REVISION TO
30L-1 SERVICE BULLETIN NO. 1

EQUIPMENT SERIES: 30L-1

EQUIPMENT TYPE: 30L-1 R-F LINEAR AMPLIFIER

SUBJECT: WIRING CHANGE REQUIRED BEFORE CONVERSION FROM 115 TO 230-VOLT OPERATION IS MADE, USE OF 8-AMPERE LINE FUSES, AND CORRECTION TO INSTRUCTION BOOK DRAWINGS.

Termination of AC Power Cord at Terminal Strip TB1

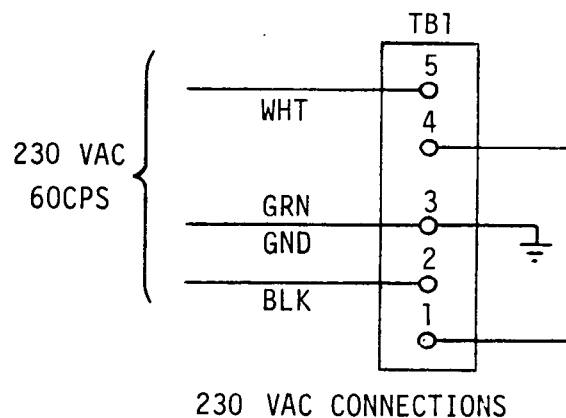
The procedure and schematic for converting operation of the unit from 115 to 230-volts, as detailed in the 5th edition of the 30L-1 R-F Linear Amplifier Instruction Book, dated 15 June 1962, is in error. These errors are corrected in the 6th edition of the above referenced instruction book, dated 15 June 1964. Before conversion is attempted the wiring changes detailed below must be made. After these changes have been made, the conversion can be made by changing the jumper wires on TB1 as shown in figure 1.

Procedure for correcting TB1 wiring to allow conversion from 115 to 230-volt operation:

1. Remove a-c power cord from the primary power source.
2. Lift the cabinet lid and remove the two Phillips-head screws located on the front panel rim.
3. Remove the four feet and the Phillips-head screw that is located between the rear feet.
4. Remove amplifier chassis from cabinet. The easiest way to do this is to place amplifier panel down on a padded surface.
5. Remove the screws from the bottom panel and both end panels of the amplifier. Lift out the bottom shield.
6. Move the white wire from the power cord from terminal 1 to terminal 2 on terminal strip TB1.
7. Move the lead of capacitor C4 from terminal 1 to terminal 2 of TB1.
8. Reassemble unit and return to operation. (Conversion from 115 to 230-volt operation and vice versa now can be made by connecting the jumper units on terminal strip TB1 as shown in figure 1.)

Figure 2

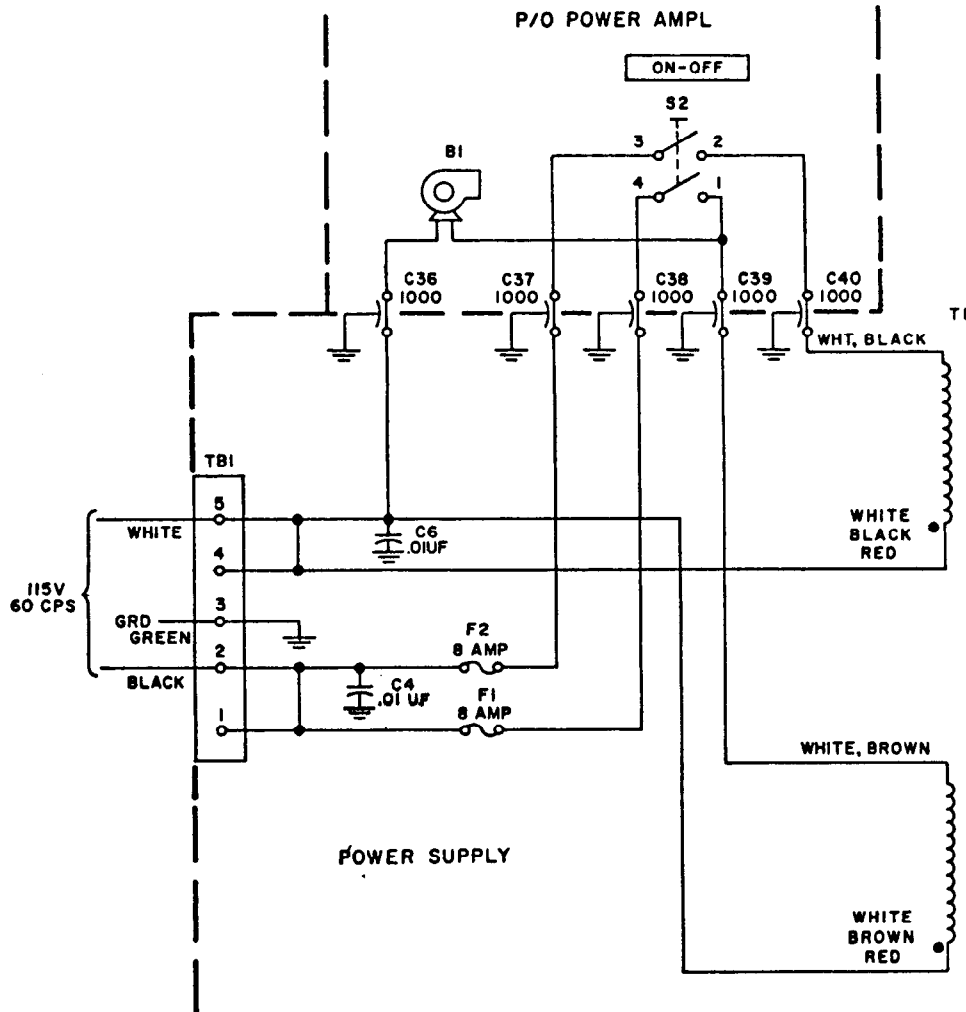
Figures 3-2 and 7-1 in the instruction book (up to and including the 5th edition) are in error and should be corrected as shown in figure 2. This correction applies only to the instruction book and does not involve changes to the equipment itself.

Corrected Partial View of Figure 7-1 in Instruction Book
